**Eugene School District 4J
ROOSEVELT MIDDLE SCHOOL**
680 East 24th Avenue
Eugene, OR 97405
CIP No. 410.566.001

ADDENDUM NO. 6

This Addendum forms a part of the Contract Documents and modifies the original Bidding Documents dated February 18, 2015 and subsequent addenda as noted below. Acknowledge receipt of this Addendum in the space provided on the Bid Form. Failure to do so may subject the Bidder to disqualification.

E-121D

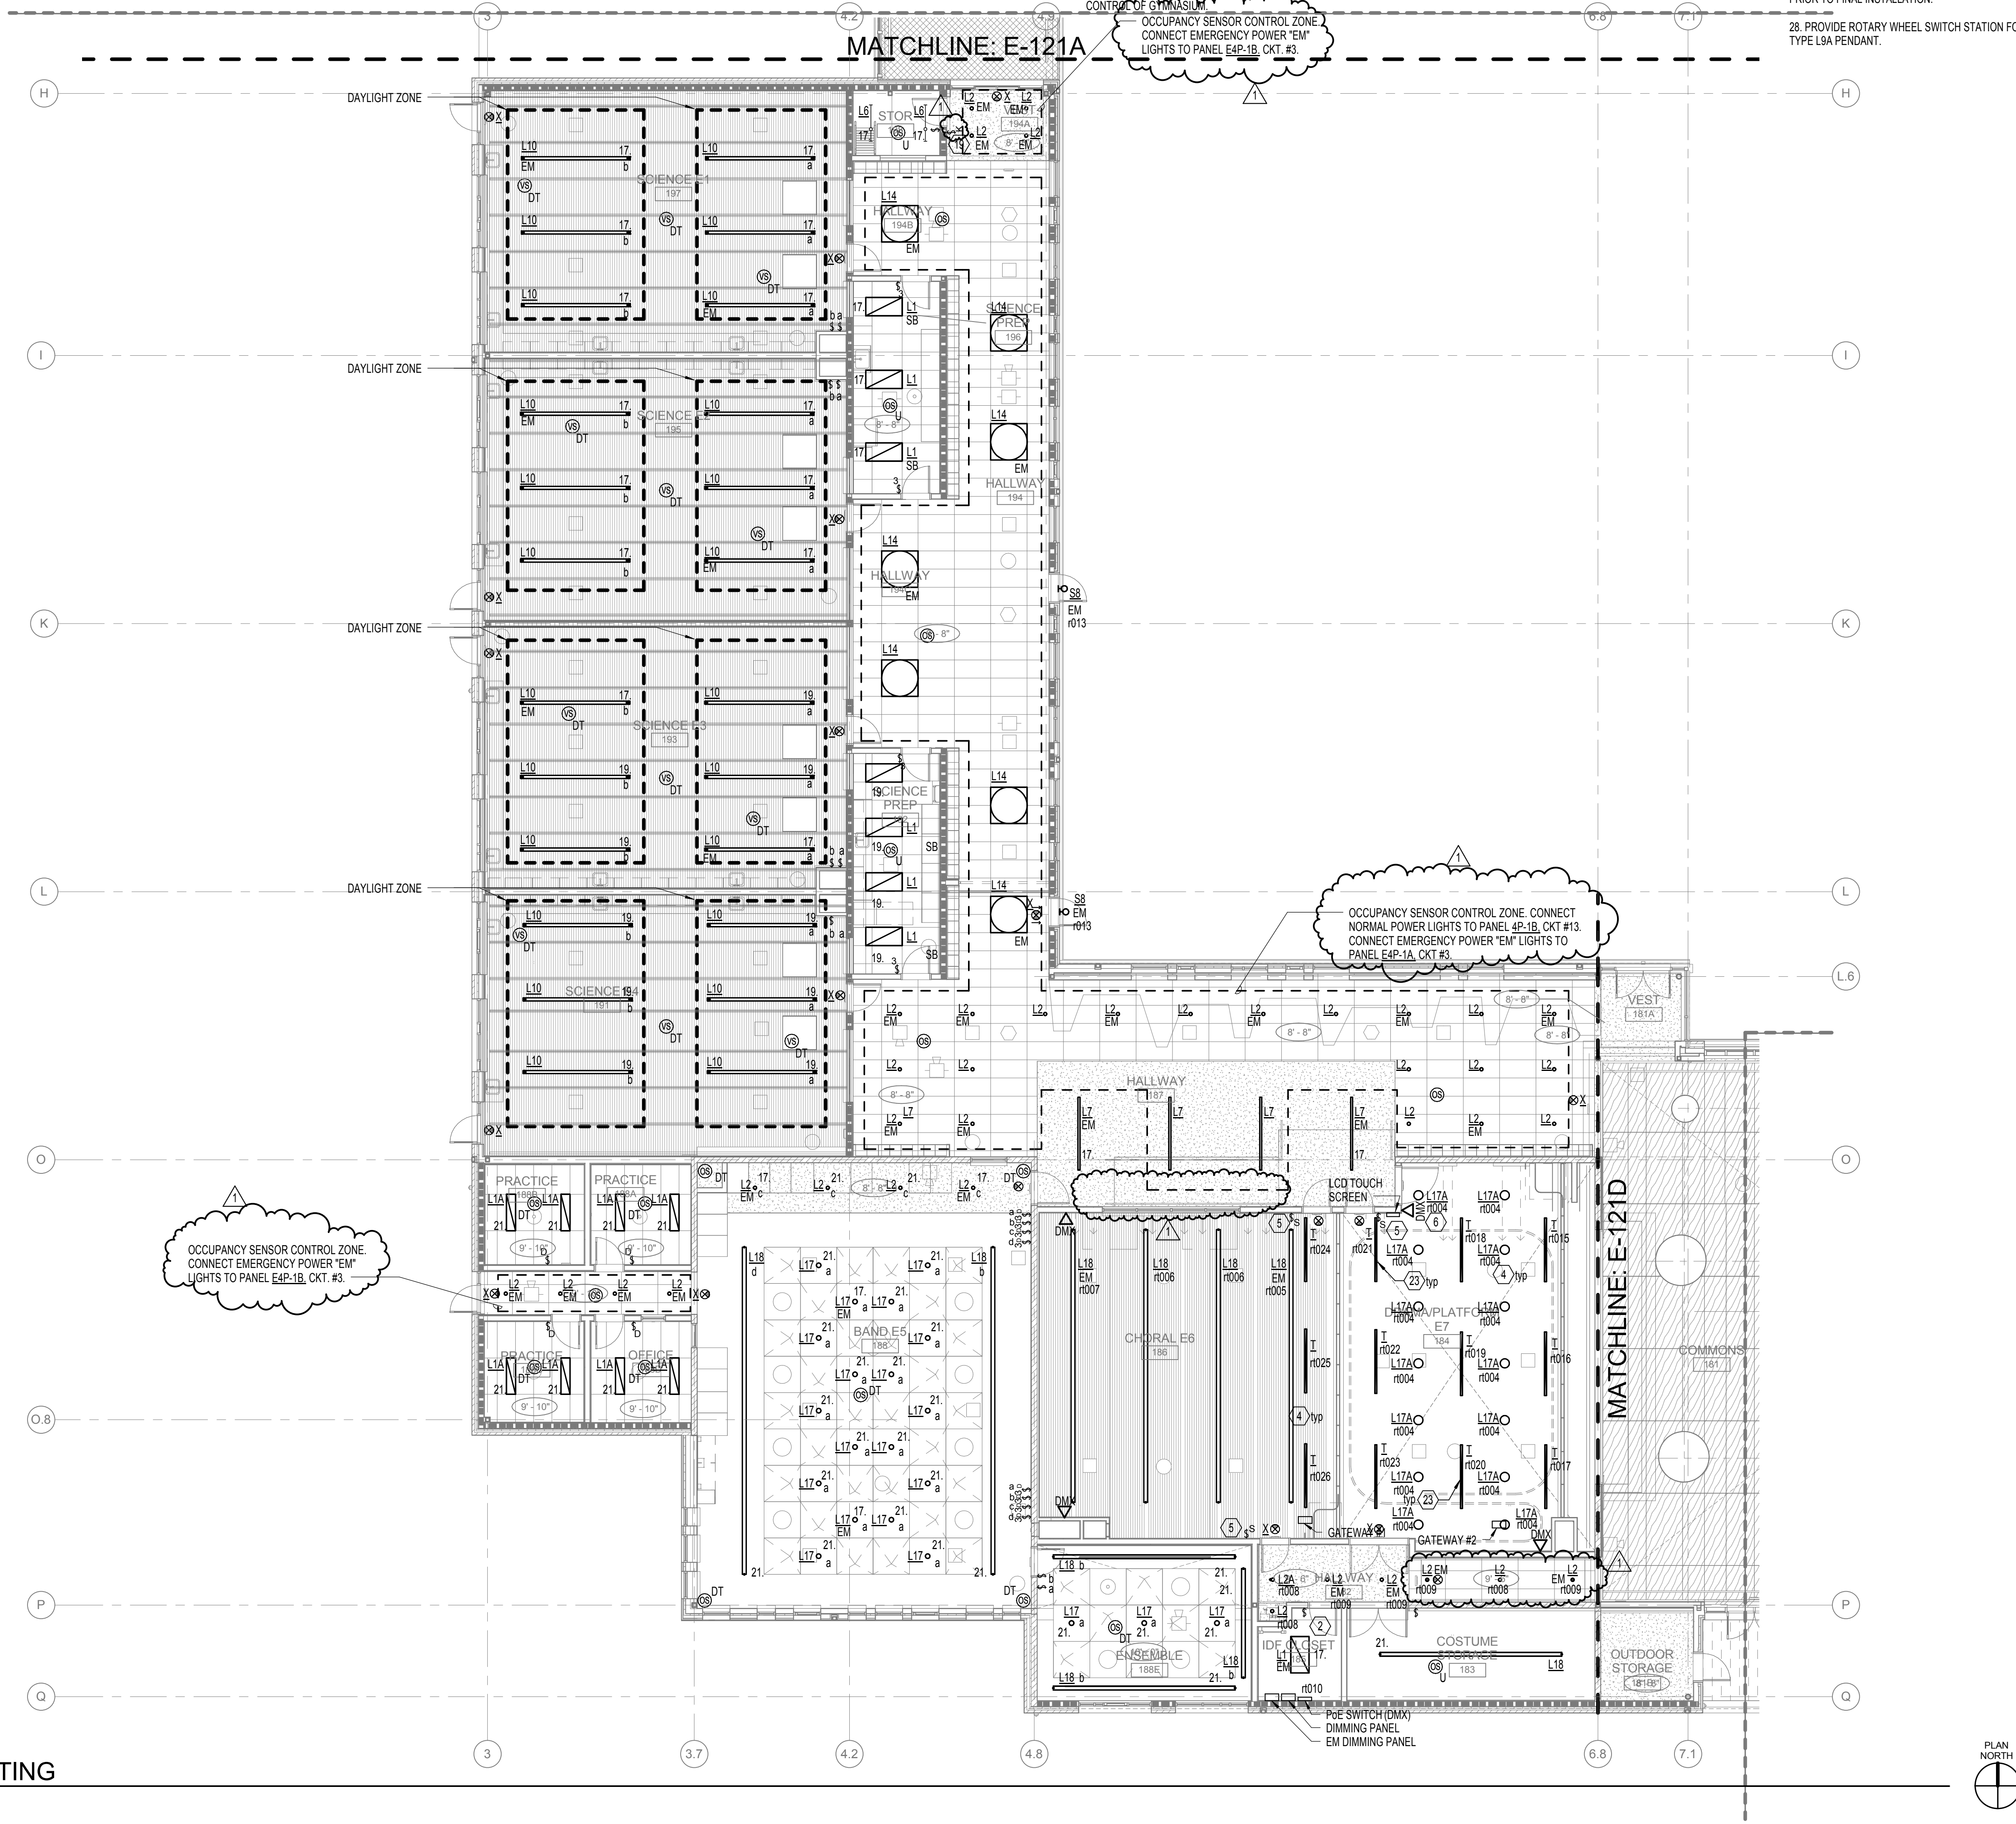
- A. Replace Sheet with revised Sheet E-121D: Remove relays for interior lighting loads tied to the DDC. Circuitry indicated. Provide UL 924 shunt relay for egress lighting in these locations as shown.

E-222A

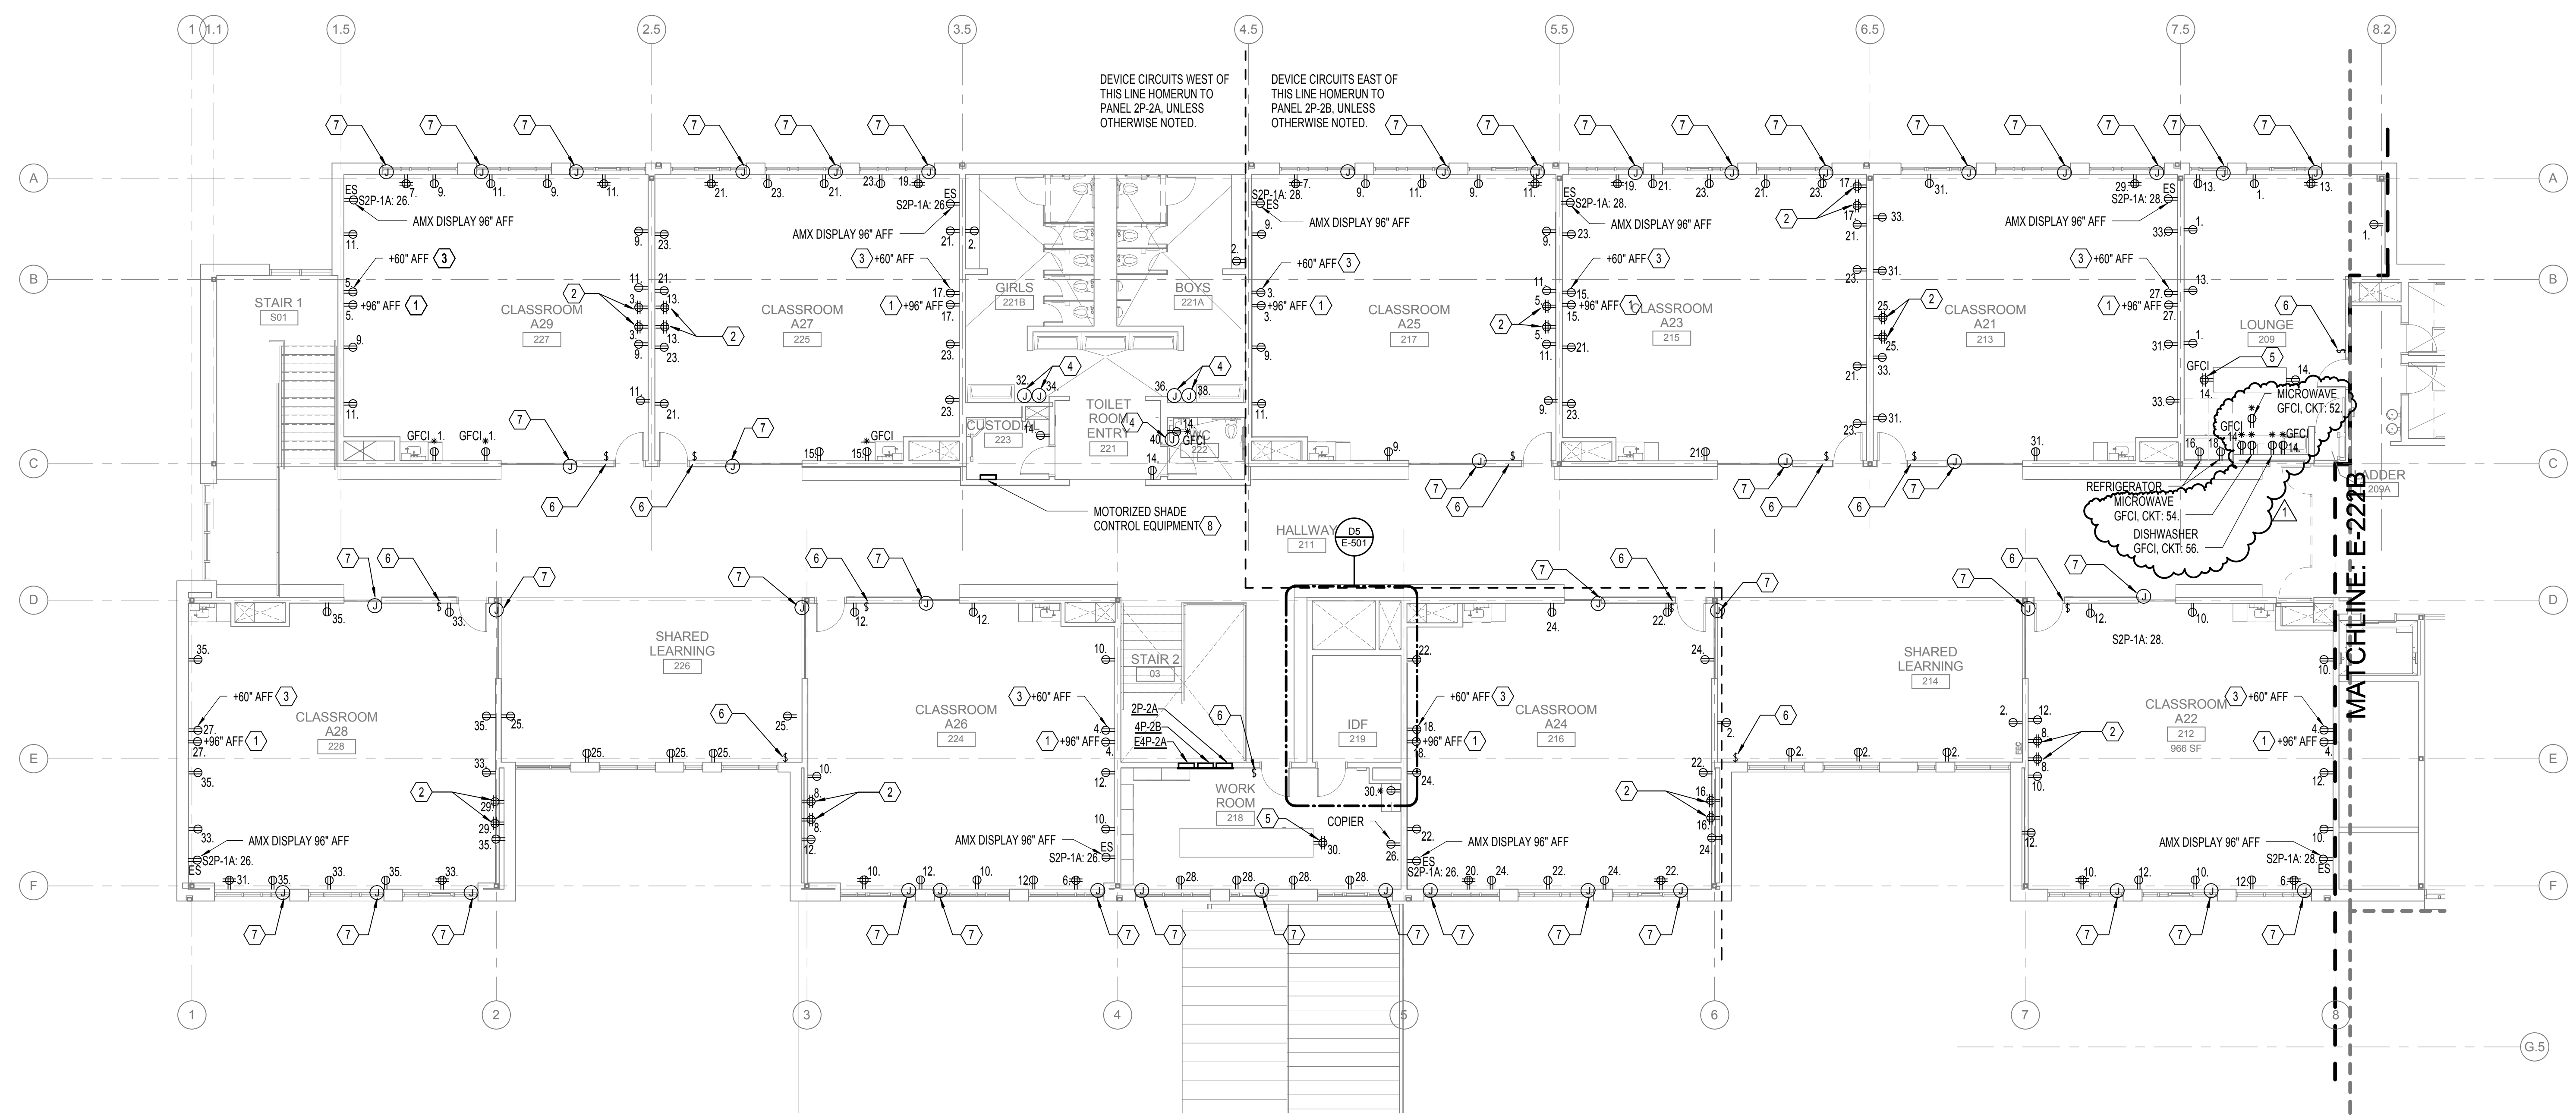
- A. Replace Sheet with revised Sheet E-222A: Add power for microwaves and dishwasher at Lounge.
